Subject: Revised Parker Street (North)
Definitive Plans
Date: September 9, 2021
Transmitted: ☐ Mail ☒ Email ☒ Hand

**Subject: Parker Street (North)
Definitive Subdivision Revision #2**

PARKER STREET (NORTH) - DEFINITIVE SUBDIVISION
LEICESTER, MASSACHUSETTS

KEY PLAN & NOTES
PREPARED FOR: SCHOLD DEVELOPMENT, LLC (OWNER/APPLICANT)
77 CHICKERING ROAD, SPENCER, MA 01562

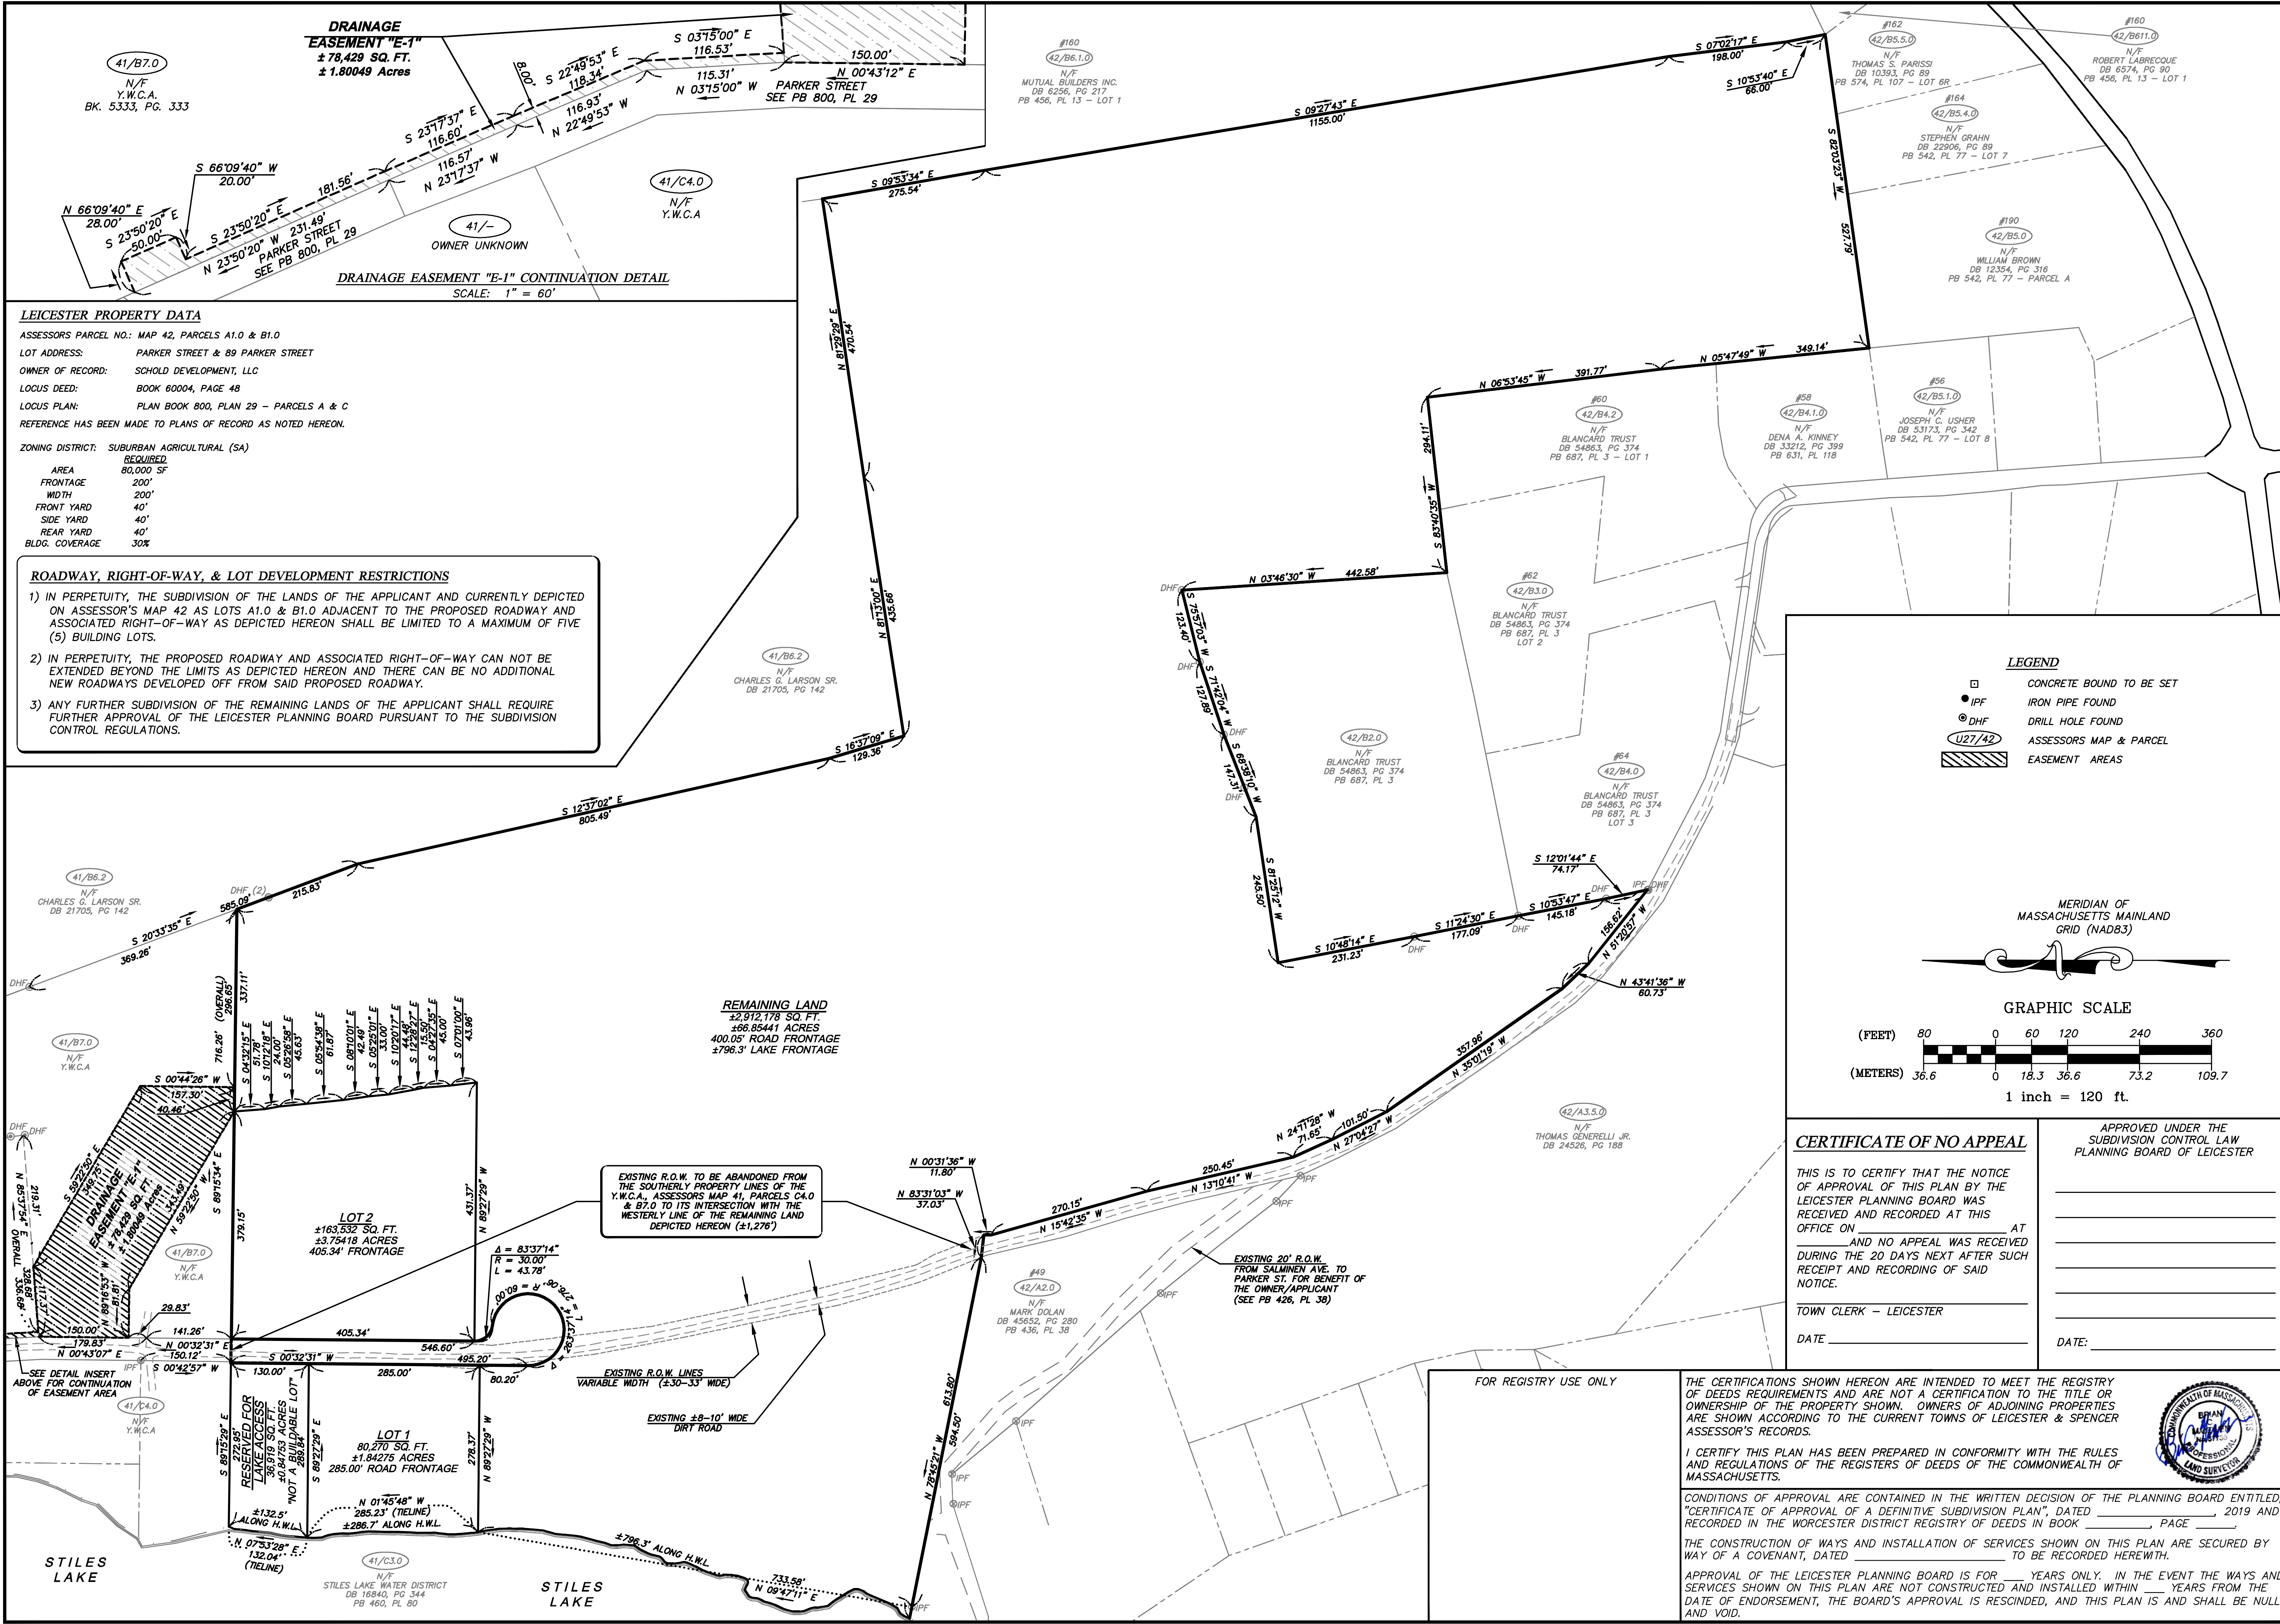
1. Sheet 1: The waiver request for overhead utilities in lieu of underground utilities has been removed.
Revised waiver request for street trees to allow waiving street trees on the easterly side of the proposed roadway.
2. Sheet 2: No Changes
3. Sheet 3: Added drainage easement detail to include the drainage swale along the easterly side of the existing Parker Street right-of-way located on the lands of the Y.W.C.A. and updated the easement area notation.
4. Sheet 4: Updated Infiltration Basin B1 location and grading as noted in Hydrology & Stormwater #6 above.
5. Sheet 5: No Changes.
6. Sheet 6: Updated Infiltration Basin B1 location and grading as noted in Hydrology & Stormwater #6 above.

WATER QUALITY SWALE/STONE CHECK DAM DETAIL
N.T.S.

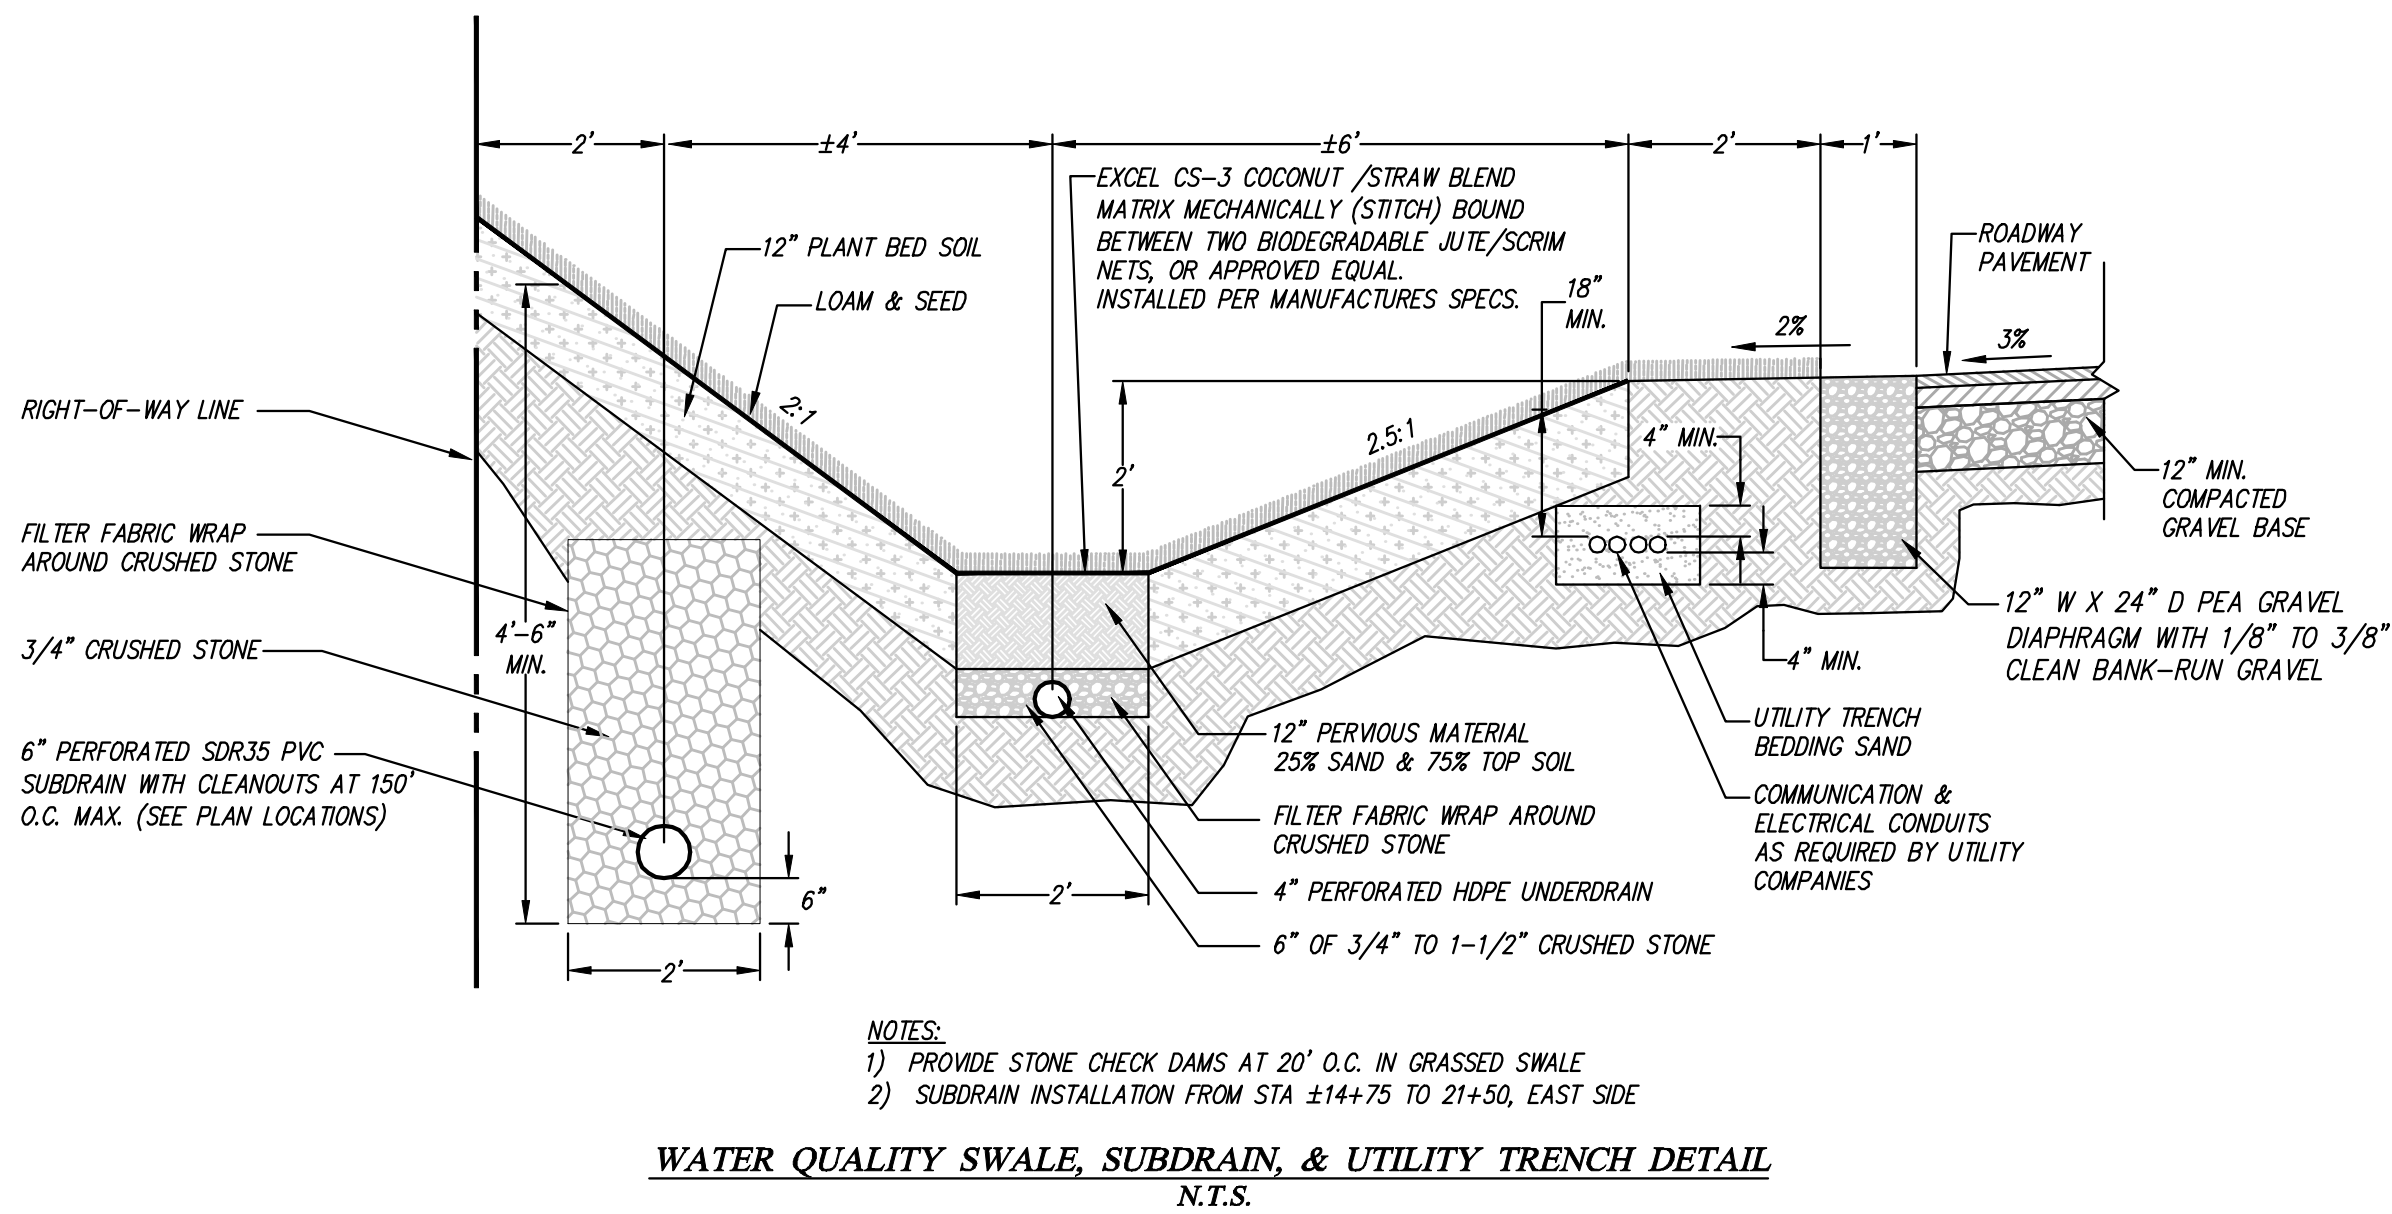
- 7. Sheet 7: Added additional construction details related to the water quality swale, level spreader diaphragm, subdrain & cleanouts, utility trench, stone check dams, and slope stabilization locations and design elevations.**
- 8. Sheet 8: Removed construction details for subdrain & cleanouts and the slope stabilization. These details have been revised and moved to Sheet 7.**
